VALUE ENGINEERING STUDY

Project # STP00-0198-01(020) PI No. 132610-

SR60 Widening & Reconstruction in Murrayville
Hall County, Georgia

23 June 2011

R-3.1 Current Design 1 of 2

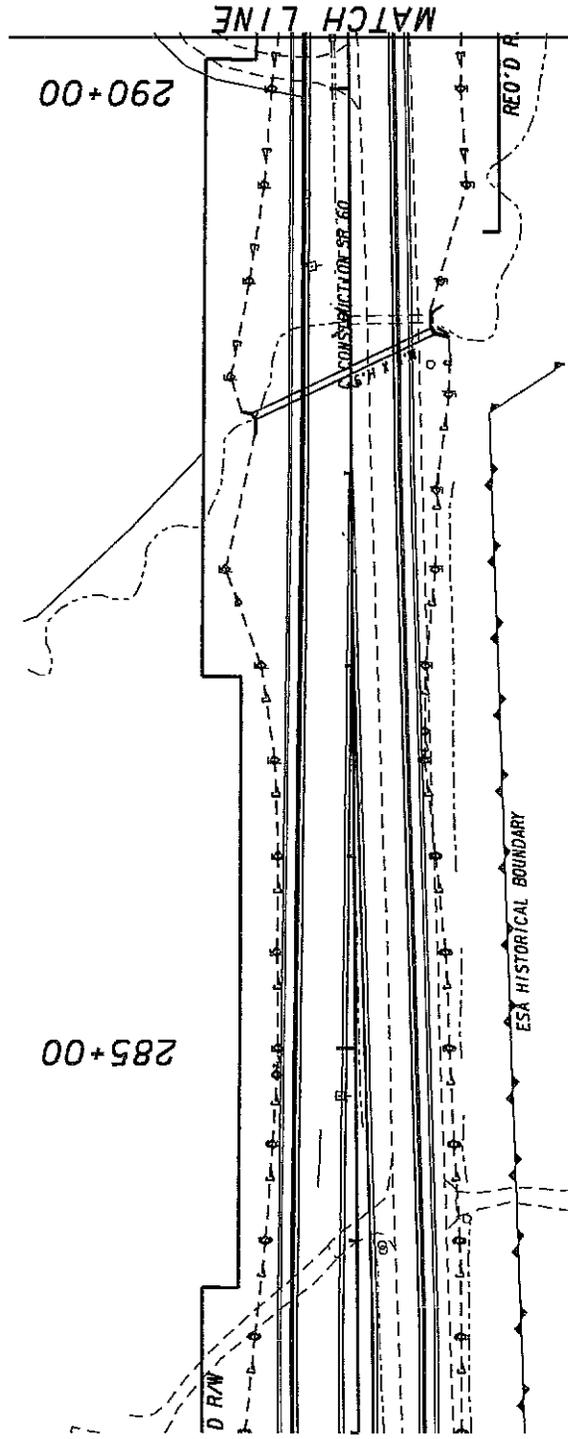
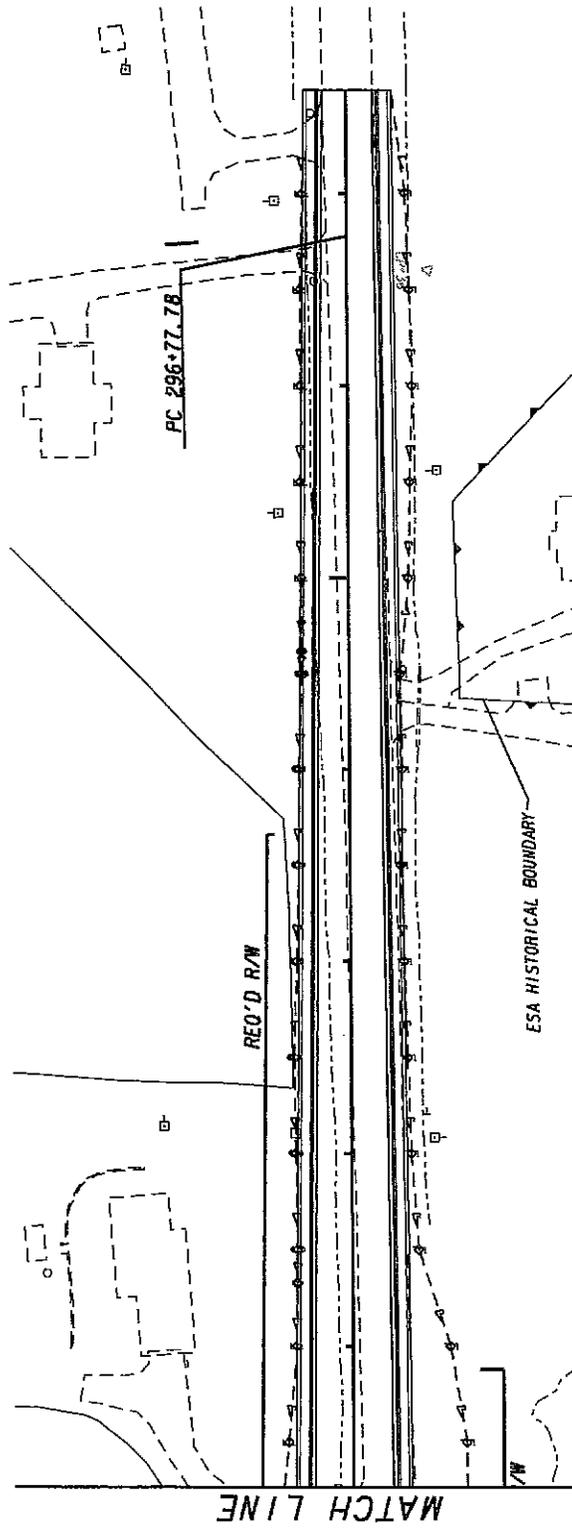
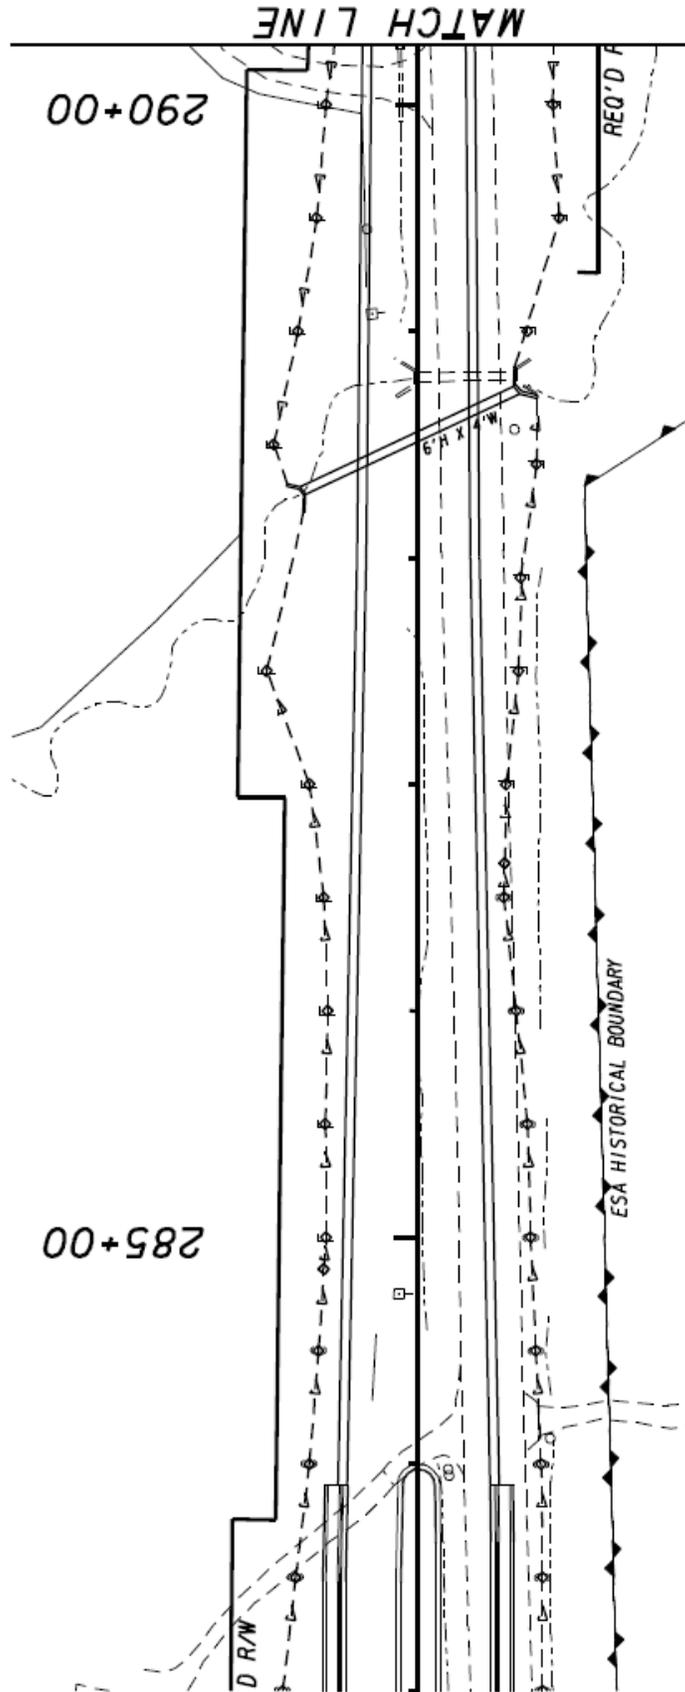
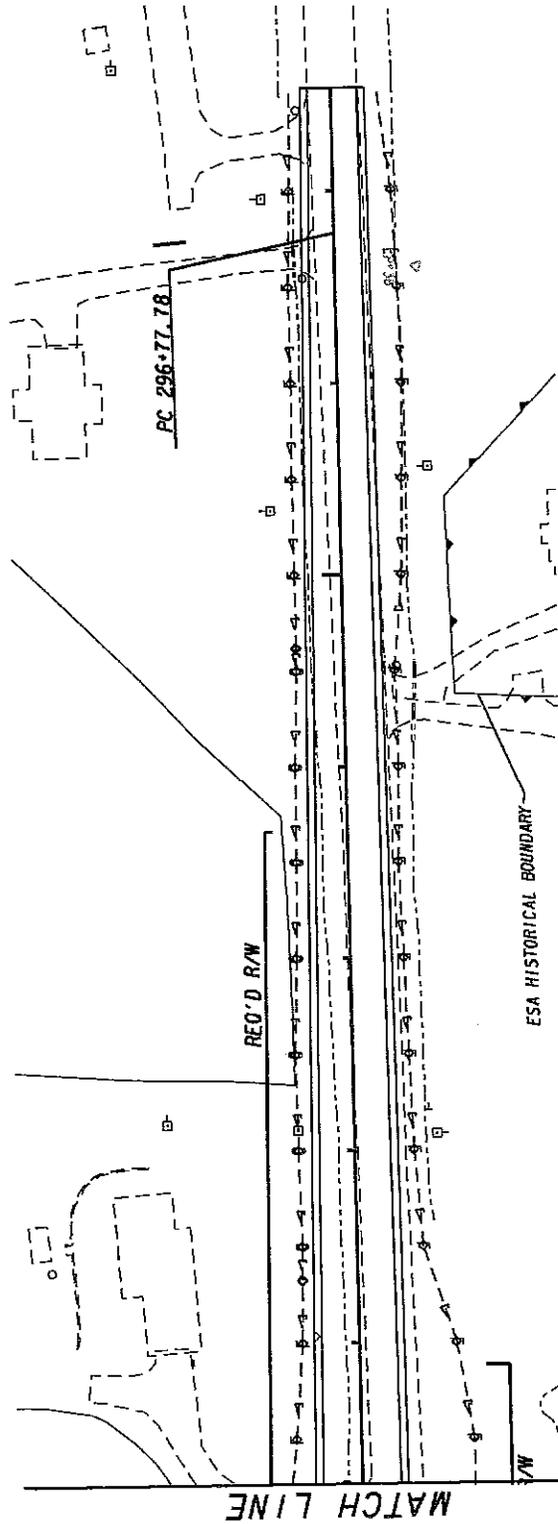
PROPOSED CHANGE: It is proposed to eliminate curb and gutter, median, closed drainage and sidewalk from the transition area from full width to existing from Sta. 284+00 to the end of the project at Sta. 297+50.

R-3.2 Plan View 1 of 1

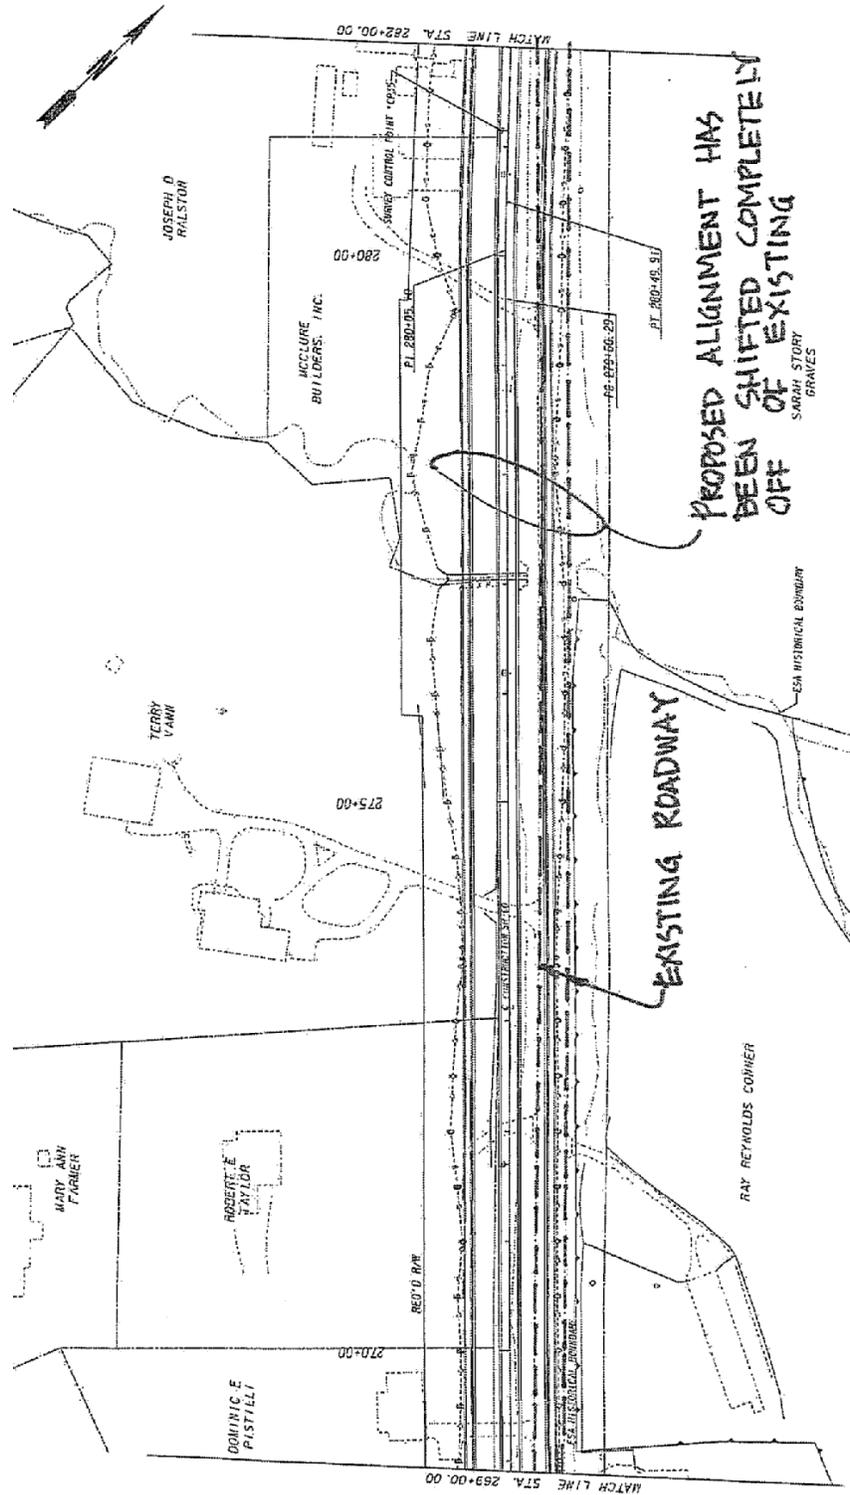
PROPOSED CHANGE: The proposed recommendation is to maintain the two northbound lanes at the same horizontal and vertical location of the existing two travel lanes.

R-7.0 Current Design 1 of 1

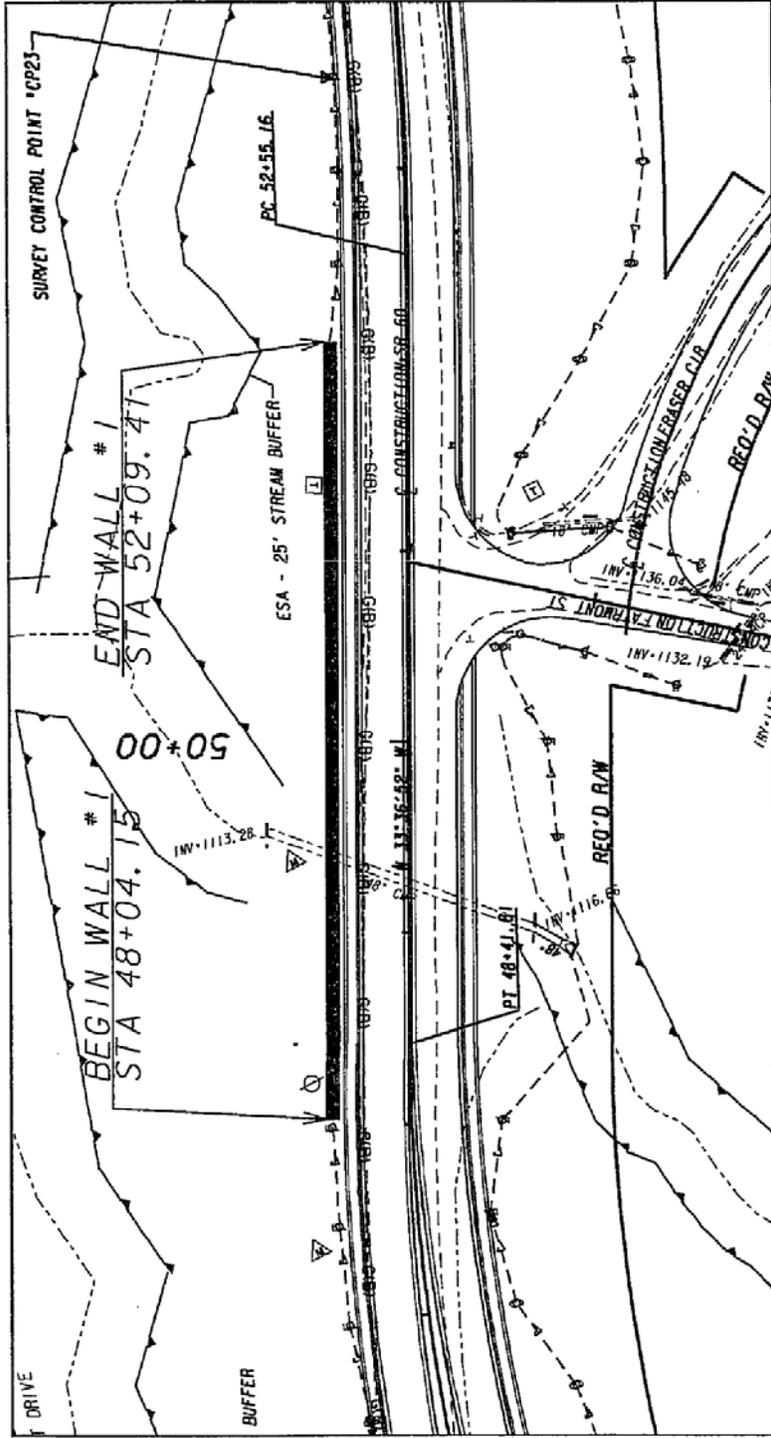
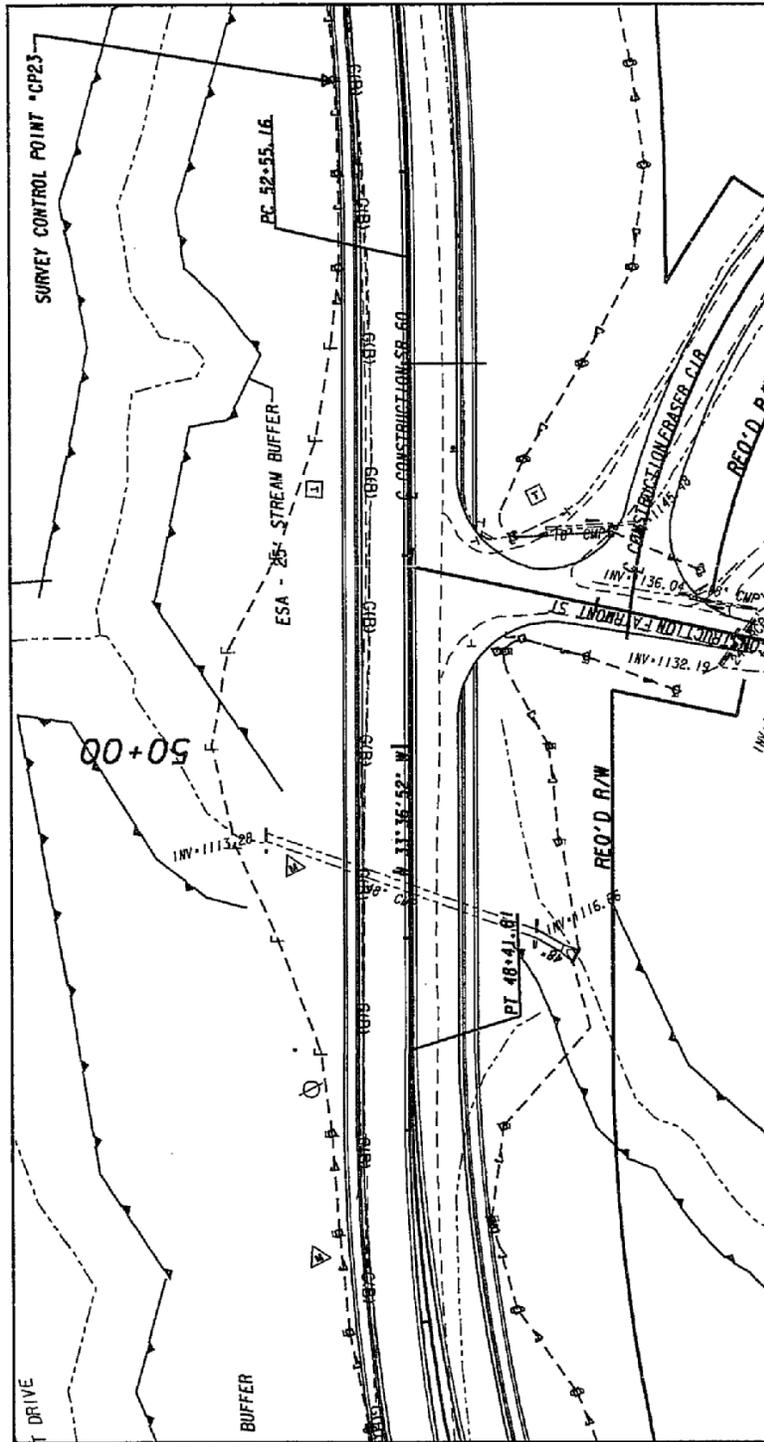
ORIGINAL DESIGN: In the current design a retaining wall is proposed from Sta. 48+04 left to Sta. 52+09 left to avoid stream buffer impacts to flowing drainage ditch. (The type and height of wall is not provided in the plans and wall is not shown on the cross sections.)

PROPOSED CHANGE: The recommendation is to eliminate the proposed 405' wall and construct fill slopes as per the proposed typical section. Also extend the existing 48" cross drain at Sta. 49+25+/-.

R-9.0 Current Design 1 of 1

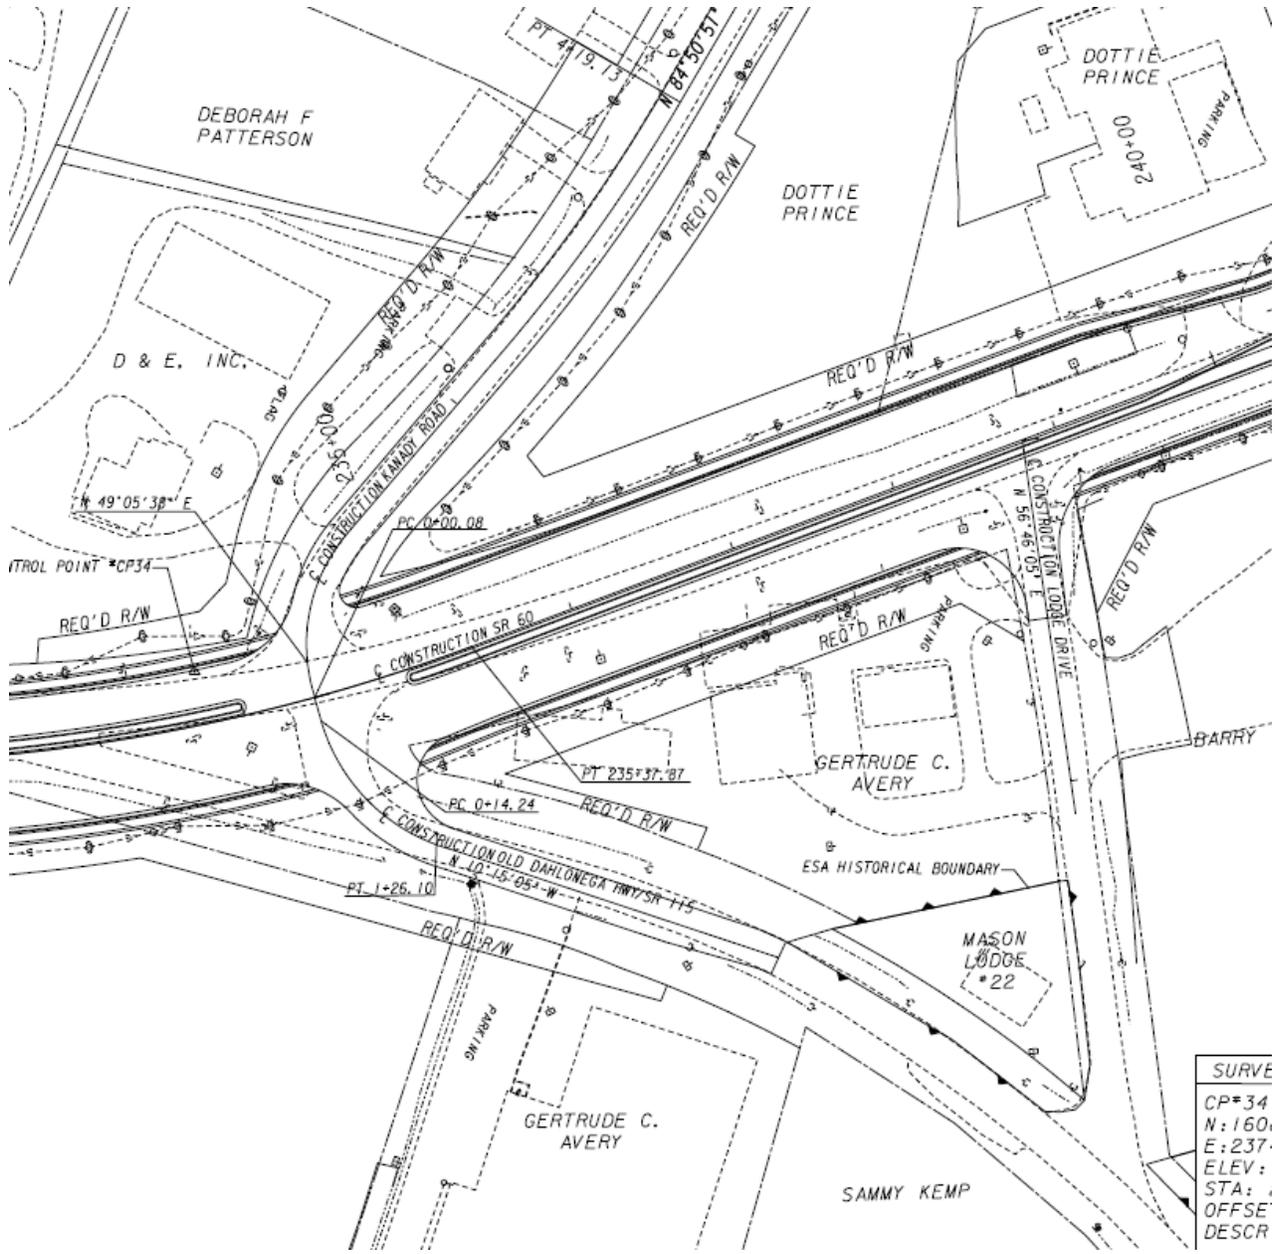
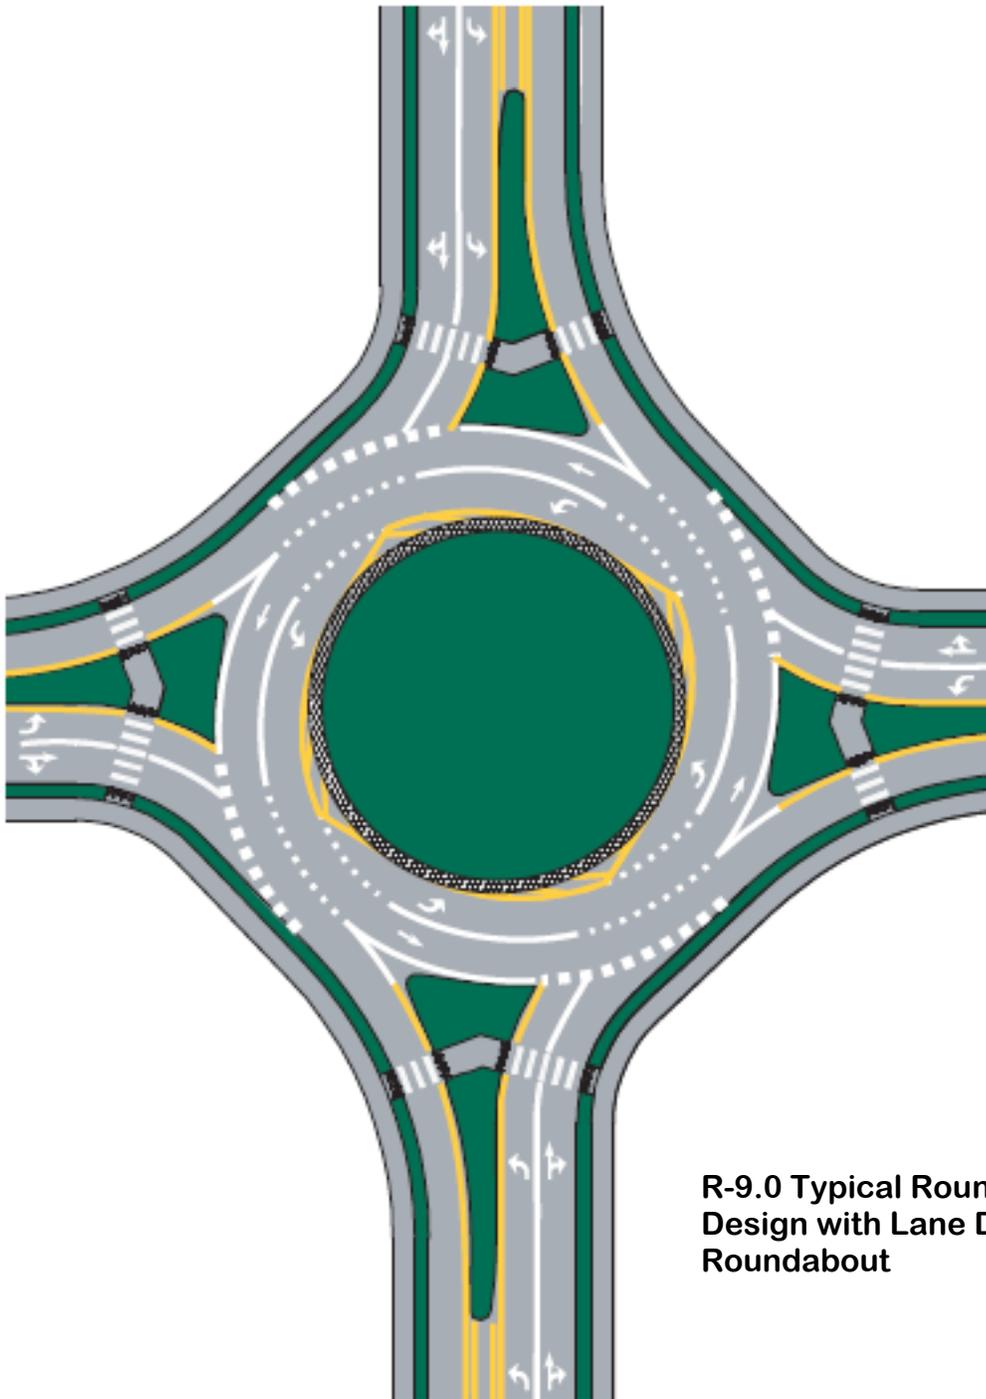
PROPOSED CHANGE: The proposed recommendation is to replace the traffic signal with a roundabout at the intersection of Dahlonega Highway and Kanady Road.
